SITE INSPECTION SHEET

OWNER: William Conley PHONE #: _____
ADDRESS: 1105 River Rd. CONTRACTOR: Oliver Hand
Sykesville WELL TAG #: no tag, pit well
SUBDIVISION: _____ LOT: _____ COUNTY #: _____
PROPOSAL: addition

LOCATION DIAGRAM

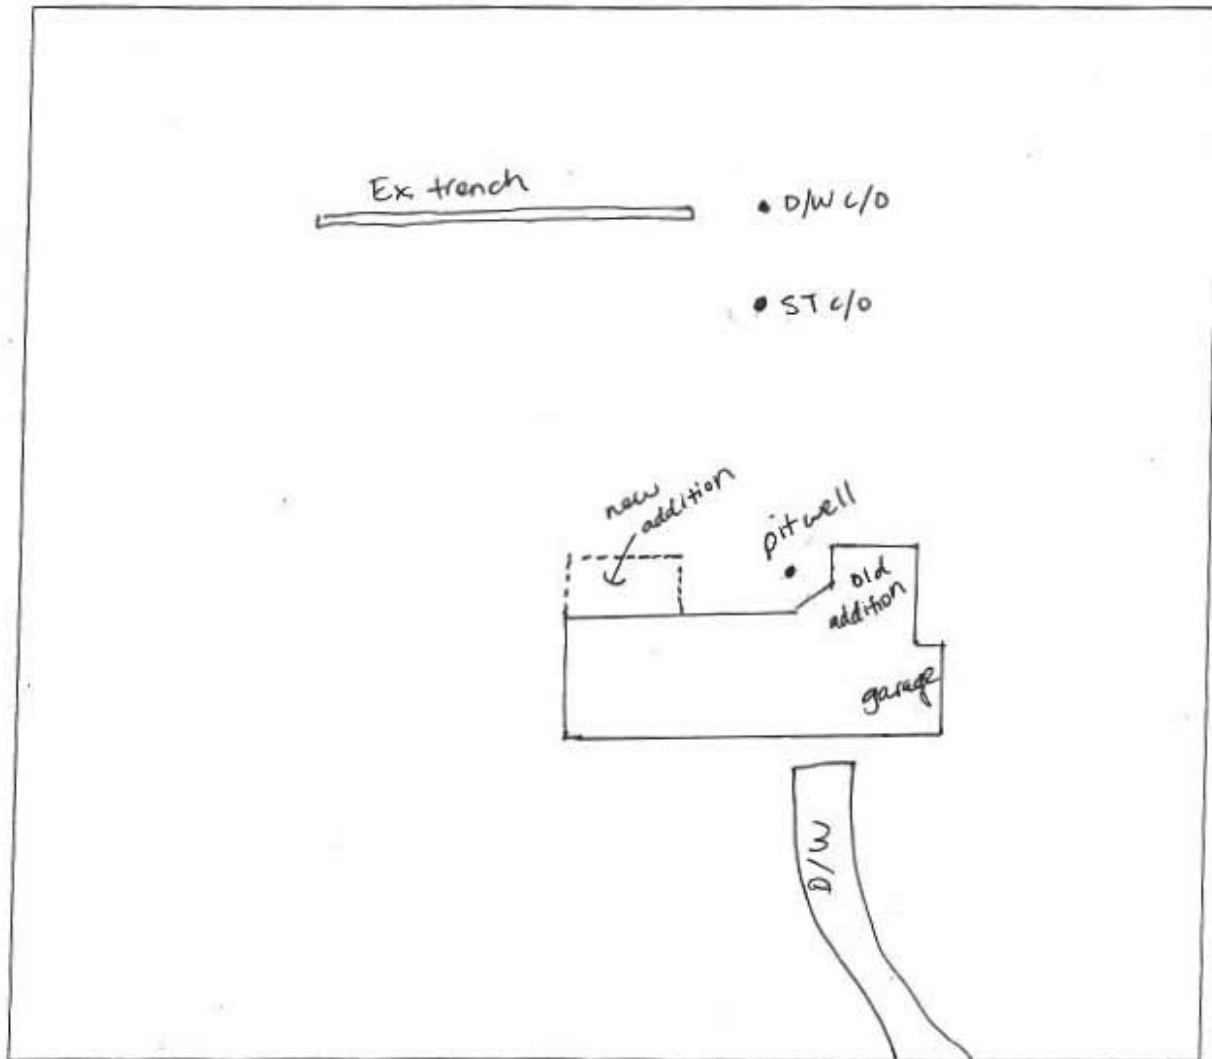
COMMENTS: Removed cleanouts from S.T. & D.W. Effluent levels OK.
Inlet depth on drywell approx 2'-2.5'. Area of trench off
of D.W. is satisfactory.

- Pit well needs to be upgraded.

Walk-thru of house confirms 2 BR upstairs
